Harrow Planning Committee AGENDA (scheduled for Wed 21<sup>st</sup> Nov at 6.30pm)

Reference Application Number: P/1472/18 to grant retrospective planning permission 121 Rowlands Avenue. We object to the following points within the sections listed below:

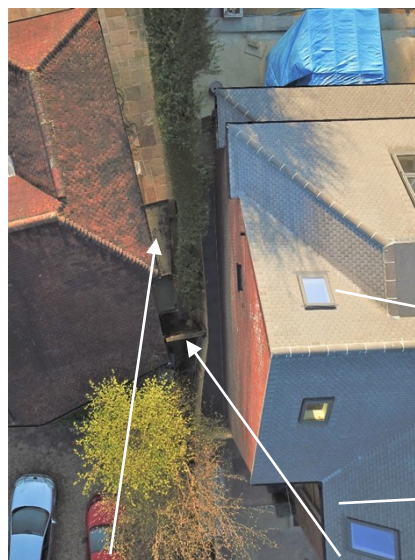
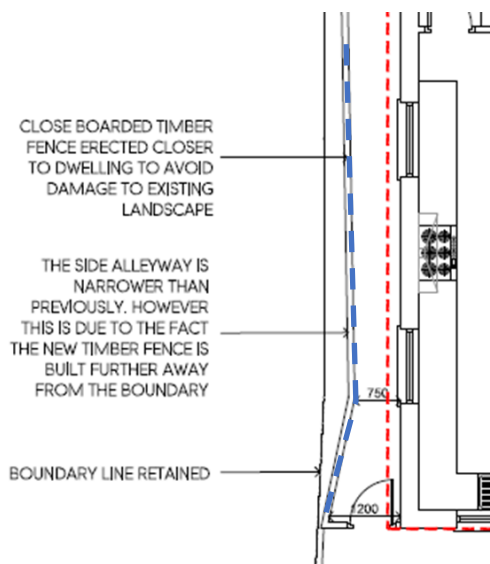
There would be a 0.75 metre gap for pedestrian access between the flank elevation of the two storey side extension and the shared boundary with No. 119.

**Correction** - Should read '*there would be a 1 metre gap*' as per approved plan P/1472/18

This element has not been built in accordance with the approved plans. The side wall has been set in from the boundary shared with number 119 by approximately 0.22m. In addition the fencing has been moved from the actual boundary and erected within number 121 to protect the greenery and this has resulted in the reduction in width of the pedestrian access.

**Correction**

The 'boundary line retained' is drawn incorrectly. The blue dashed line superimposed on the drawing below and white line on the aerial photo is the true boundary. The 'boundary line retained' as marked on the submitted drawing would cut through our downstairs toilet and side gate clearly displayed on the photo. We request a site visit to confirm the boundary error and correct (accurate) drawings submitted by 121 to enable 119 to retain the correct boundary line between properties before any decision is made.

Downstairs Toilet

Side gate

The fence has not been erected within 121's land to protect greenery. The reduced width of the passageway is as a direct result of the size of the extension. The hedge is and has always been within 119's land. This is inaccurate information provided by the architect. It is hearsay and needs removing from the report.
